E5052A-05

S E R V I C E N O T E

E5052A Signal Source Analyzer

When replacing A51 LCD, fasten the TORX T15 screws using a torque screwdriver (set to 1.02 N-m / 9.0 lb-in).

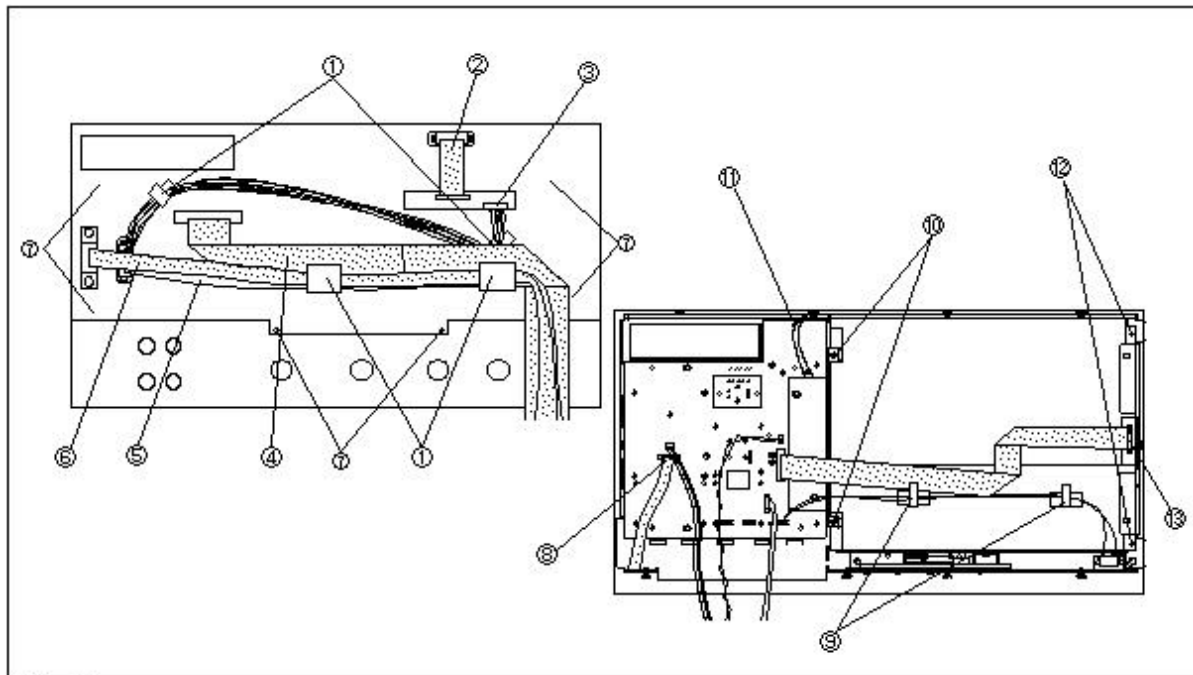
When replacing the A51 LCD, no torque info is shown in the service guide.

If you fasten the screw with over the appropriate torque, A51 LCD might be damaged, and if you fasten the screw with under the appropriate torque, LCD module might not be fixed against the vibration.

Fasten the TORX T15 screws (item 10 and item 12) using a torque screwdriver (set to 1.02 N-m / 9.0 lb-in).
